**COMMONWEALTH OF KENTUCKY
BEFORE THE PUBLIC SERVICE COMMISSION**

ELECTRONIC 2021 JOINT INTEGRATED)
RESOURCE PLAN OF LOUISVILLE GAS) CASE NO. 2021-00393
AND ELECTRIC COMPANY AND)
KENTUCKY UTILITIES COMPANY)

**JOINT INTERVENORS' INITIAL COMMENTS ON LOUISVILLE GAS AND
ELECTRIC COMPANY AND KENTUCKY UTILITIES COMPANY'S
JOINT 2021 INTEGRATED RESOURCE PLAN**

Report on Louisville Gas and Electric Company and Kentucky Utilities' 2021 Integrated Resource Plan

Figure 1. The Companies’ Modeling Process

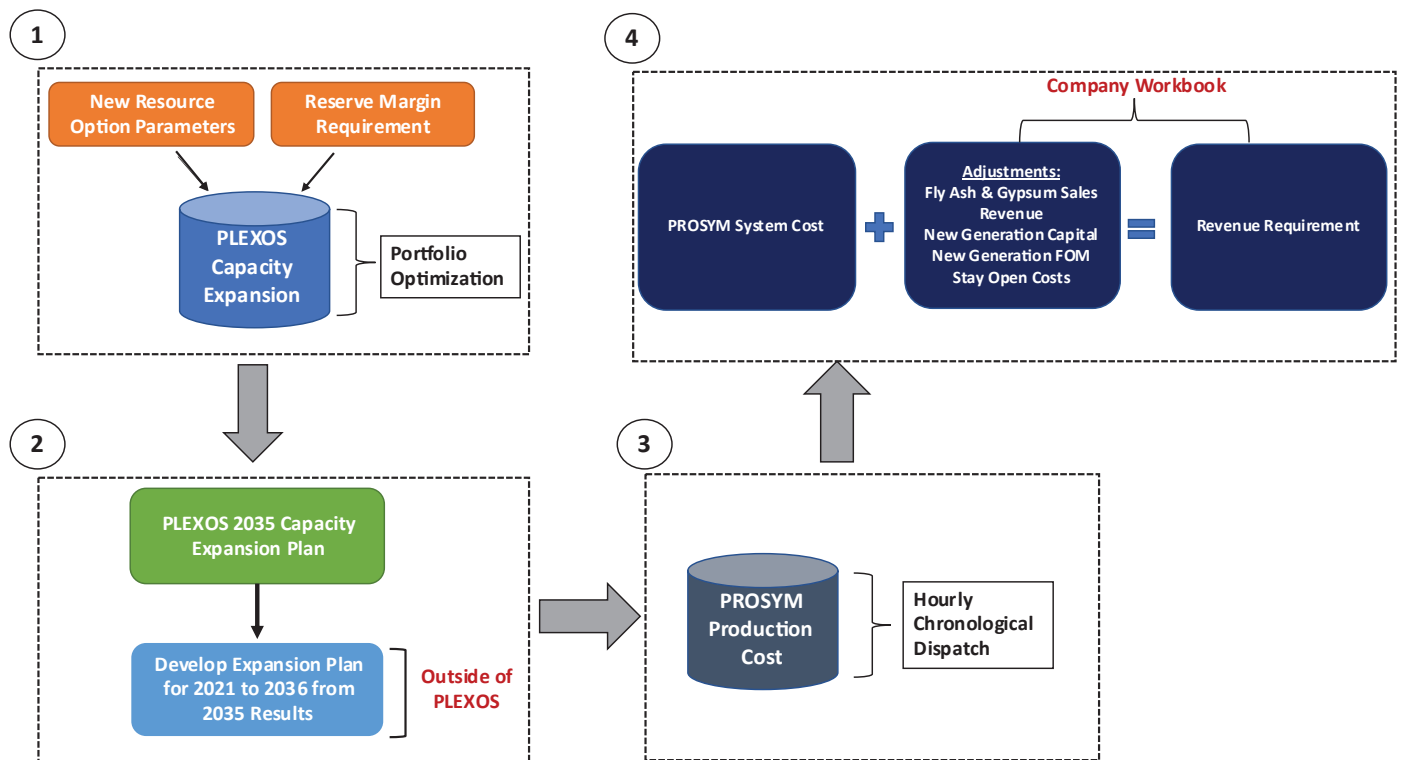
The Companies then combined different pieces of these analyses, made certain out-of-model adjustments to costs, and then created a set of revenue requirements. Those steps are shown in Figure 1, below. The out-of-model adjustments included accounting for fly ash and gypsum sales revenue, the capital and fixed O&M costs for new generation, and the Companies’ calculation of the fixed O&M and capital maintenance⁷ for existing resources.

We have serious concerns about the Companies’ modeling approach for this IRP. Figure 2 depicts the modeling process that we usually see utilized by utilities using PLEXOS for IRP modeling.

Figure 2. Capacity Expansion and Production Cost Modeling Process

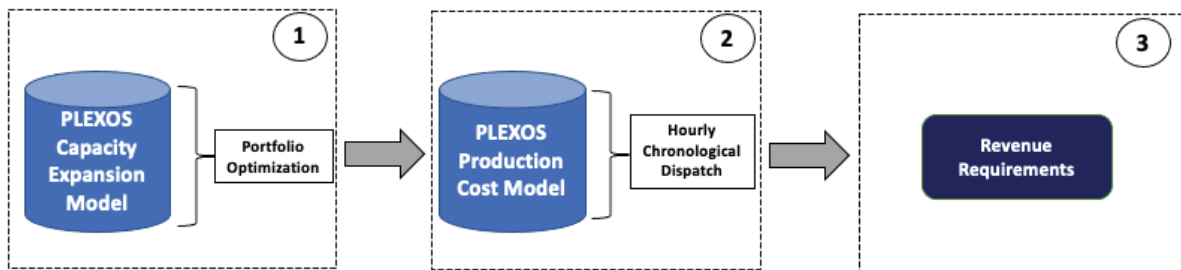
It is more traditional for utilities to leverage the same software for the capacity expansion and production cost modeling steps and not break these two steps out into two different models. For example, the three primary electric system models we see used in IRPs, EnCompass, Aurora, and PLEXOS, all have the capability to perform capacity expansion and production cost modeling. There are a variety of reasons for the use of one model, the first being that it's more cost-efficient to do so, as only one license fee has to be paid. Another is that it reduces the opportunity for errors. While these models typically require similar types of information, they have different formatting requirements, so there is room for additional errors in translating the data from one model into the format required for another model. A third reason is that using one model saves time. It's much easier to launch a production costing run immediately after the capacity expansion run if the same model is used. In fact, at least one of these models can be scripted to do that automatically. Finally, there isn't such a huge differential in tool capabilities that it would make sense in most circumstances to use one of these tools for capacity expansion modeling and another for production cost modeling. There may be reasons to use two modeling tools when there are additional purposes in mind, e.g., a resource adequacy or reserve margin study, because tool capabilities become a more salient point. So the use of SERVIM for that purpose makes sense. But for IRP modeling purposes, it's hard to envision a reason to use more than one tool.

Figure 3. Distributed Generation Forecast Scenarios

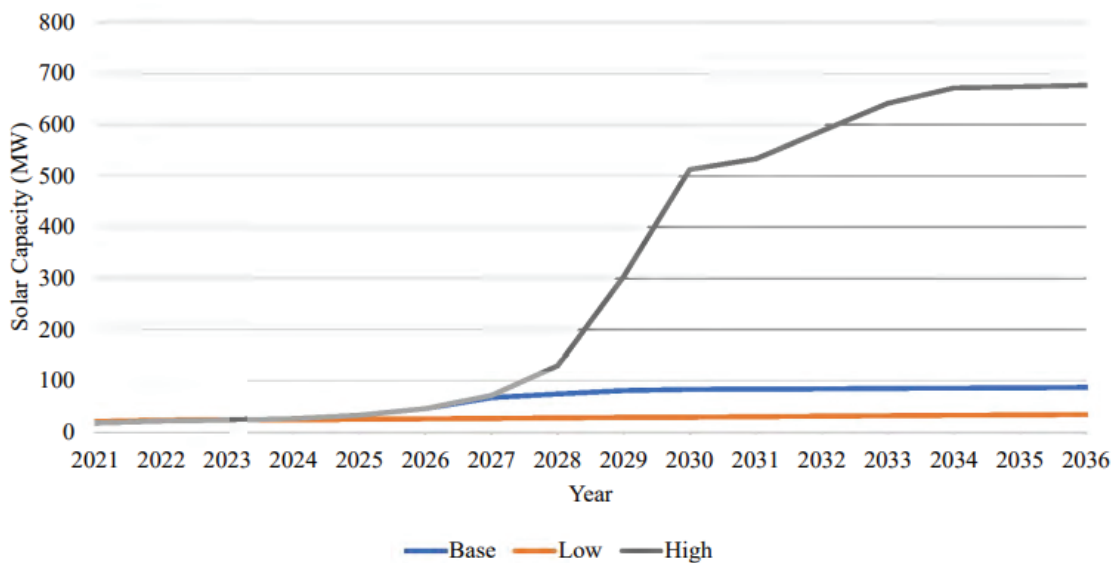
While not as frequently the subject of economic evaluation in IRPs as DSM, distributed solar may have the ability to play an important role on the Companies' system and ought to have been evaluated here. As shown in Figure 5-13 of the IRP, replicated here as Figure 3, the Companies foresee the potential for significant buildout of distributed solar. In the IRP, the Companies state that "in the high scenario, a new federal law is assumed to eliminate the 1% cap on total installed net metering capacity." However, it's important to recognize that the 1% threshold is not, in fact, a cap that limits the utilities' ability to offer net metering. The relevant Kentucky statute says, "If the cumulative generating capacity of net metering systems reaches one percent (1%) of a supplier's single hour peak load during a calendar year, the supplier **shall have no further obligation** to offer net metering to any new customer-generator at any subsequent time [emphasis added]."¹⁴ In other words, utilities have the option to continue offering net metering beyond the 1% threshold. The Companies can and should consider the value of offering additional net metering through the IRP. There are a number of tools available that would allow the Companies to create supply curves of distributed solar and their associated incentive costs. That curve can be offered to the IRP model as one of many resources to select.

The supply curve can also be tailored as dictated by the circumstances of the Companies’ system. For example, net metering is a key measure to ensure affordability for low-income customers, so the revenue requirements impacts of a program open exclusively to this group could be evaluated.

Figure 4. Scarcity Price Curve Used in Reserve Margin Study

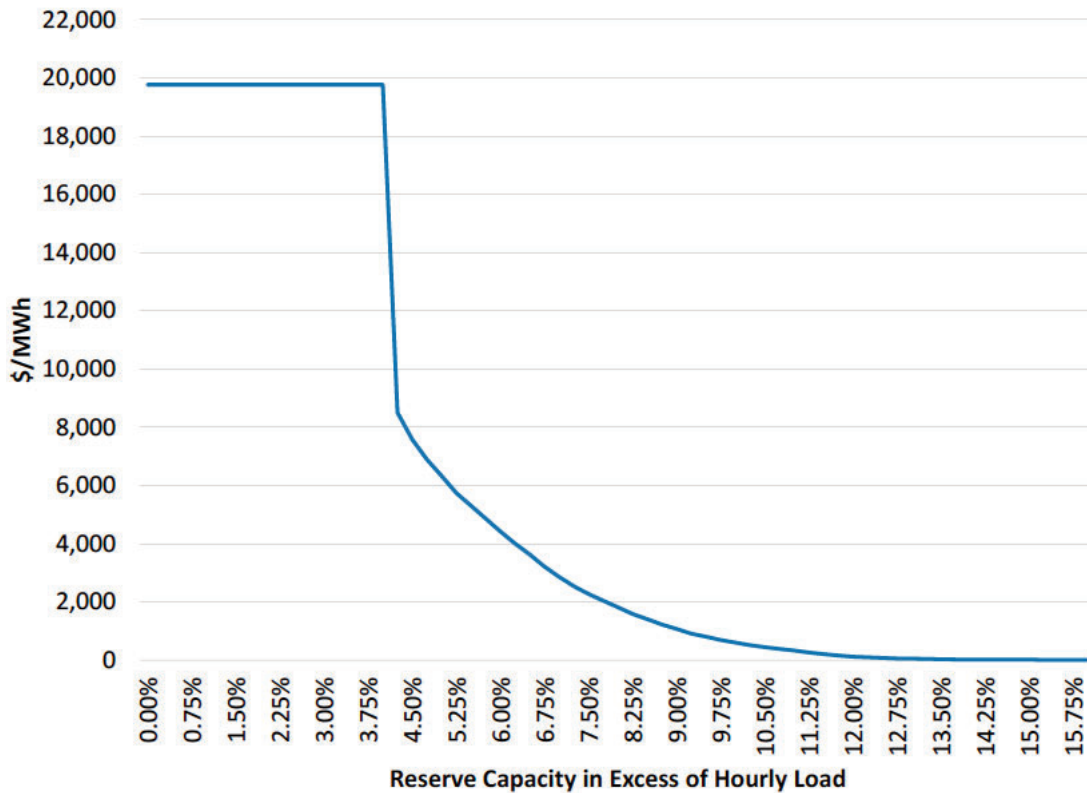
Additional improvements to the SERVM modeling would enhance the accuracy and value of these results in future analyses. For example, while it is a positive that the Companies included neighboring regions PJM, MISO, and TVA, the Companies imposed what they term “scarcity pricing” onto market interactions with those regions. The scarcity price curve is shown in Figure 4.

This graph shows that in any hour of the SERVM simulation in which the amount of capacity in excess of load falls below 15.25%, a scarcity price would be assessed on any transfers of power between a neighboring region and the Companies’ service territory (and we presume vice versa, though it’s not clear in the report or modeling files). That price grows quite rapidly from a low of \$20 per MWh to \$226 per MWh at 11.5% reserve and tops out at \$13,760 per MWh at 3.5% excess capacity or less. Indubitably, wholesale power prices rise when demand is high and generation constrained, but we’re skeptical that an increase to these levels is warranted. We examined hourly real-time pricing at the LG&E-MISO and the PJM-EKPC interfaces³² over the last four years as shown in Table 6.

Figure 5. Actual LGEE 10-minute Area Control Error (Imbalance) for 2021⁴⁷

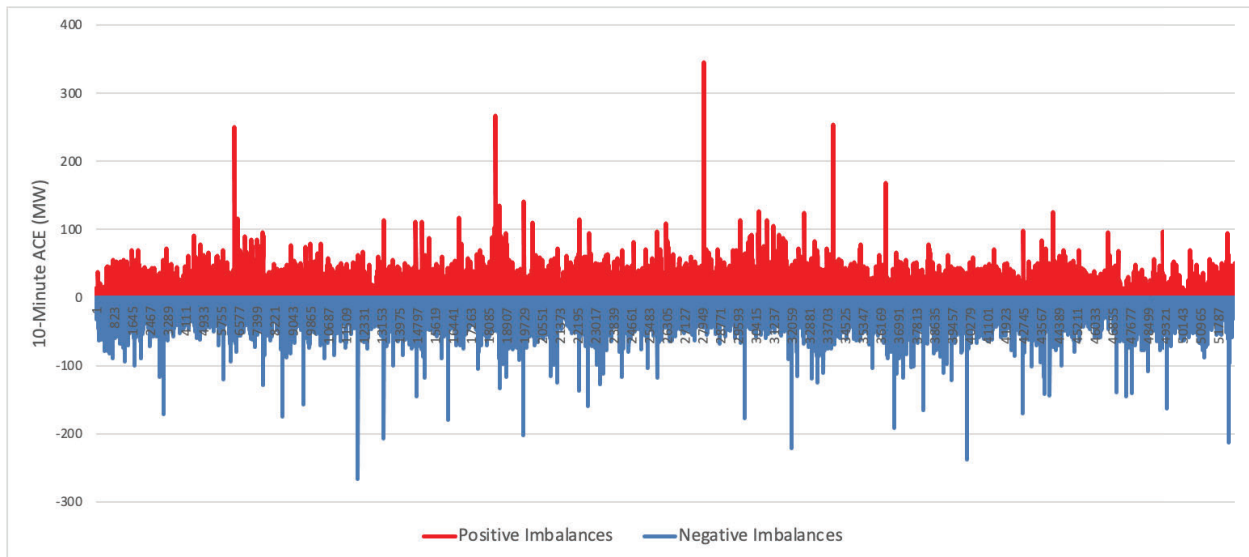
The North American Electric Reliability Corporation (“NERC”) balancing standards are assessed on a greater than 5-minute basis⁴⁶ and allow for both positive and negative excursions for specified durations before a violation would occur. Historic imbalances, known as Area Control Error (“ACE”) are recorded at 10-minute and 1-minute intervals. ACE data reported by the Companies show that positive and negative imbalances are the norm for system operations, see Figure 5, below. Note that these are not

At no point in 2021 was the Companies' system perfectly in balance on either a 10-minute or 1-minute interval. Without additional information about the rationale for the claim that there are significant imbalances with 1,000 MW of solar on the Companies' system and more information about the analysis performed, it appears that the Companies are imposing a standard on solar that they cannot meet today with the existing portfolio.
